Product Change Notification (PCN)

PCN Number: PCN_SwRSTV_20260926 Affected Series: WS-RSTV Affected Part Number: see table "PART NUMBER, REVISION & DATASHEET" PCN Date: 2026-06-26 (YYYY-MM-DD) Effective Date: 2026-09-26 (YYYY-MM-DD)	Change Category: ☐ Equipment/Location ☒ General Data ☐ Material ☐ Process ☐ Product Design ☐ Shipping/Packaging ☐ Supplier ☐ Software
Contact: Product Management Phone: +49 (0) 7942 - 945 5001 Fax: +49 (0) 7942 - 945 5179 E-Mail: pcn.eican@we-online.com	Datasheet Change: ☒ Yes ☐ No Attachment: ☐ Yes ☒ No

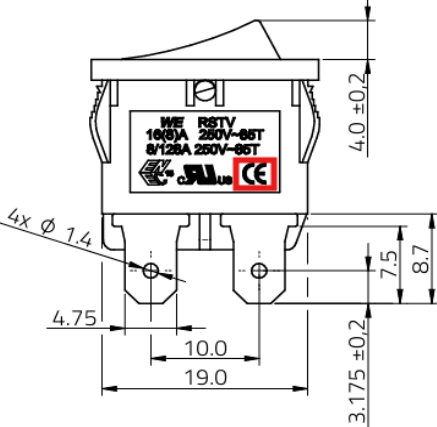
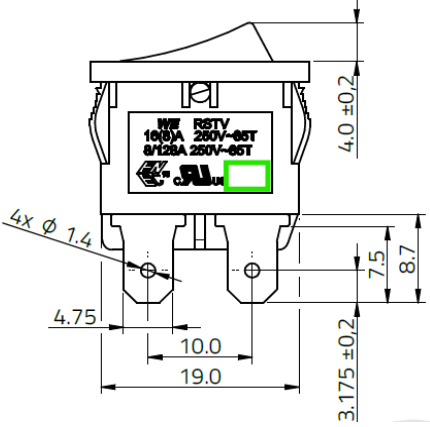
Because of a database mismatch, Würth Elektronik eiSos has corrected the datasheet drawing by removing the CE mark.
